**Office Action Summary**

09/710,362

### *Claim Rejections - 35 USC § 102*

**FIG. 13**

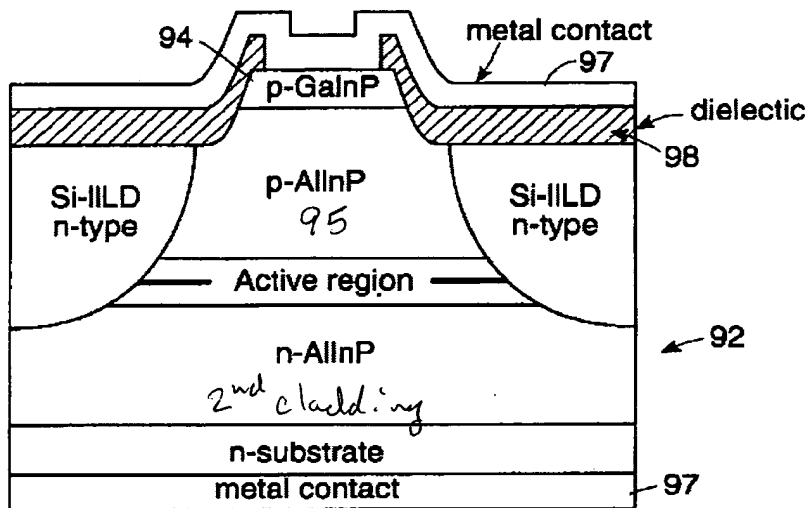
Regarding claim 24, Beernink discloses, especially in Figs. 11-13 and the discussion thereof on col. 8, a ridge waveguide semiconductor laser diode comprising a first cladding layer 95 having a ridge with a first width at the bottom of the ridge, a second cladding layer, an active layer disposed between the first and second cladding layers, a first conductor layer 97 disposed on top of the ridge, and a second conductor (also 97) for conducting current through the active

layer. The active layer has a defined gain region (the part marked "Active region") that conducts the current and has a width greater than the width of the bottom of the ridge. There are reduced conductivity regions within the active layer and flanking the defined gain region.

Regarding claim 31, the reduced conductivity regions are implanted with high-energy ions.

Regarding claim 34, Beernink discloses that there may be an insulating layer 98 disposed adjacent the first conductor layer 97.
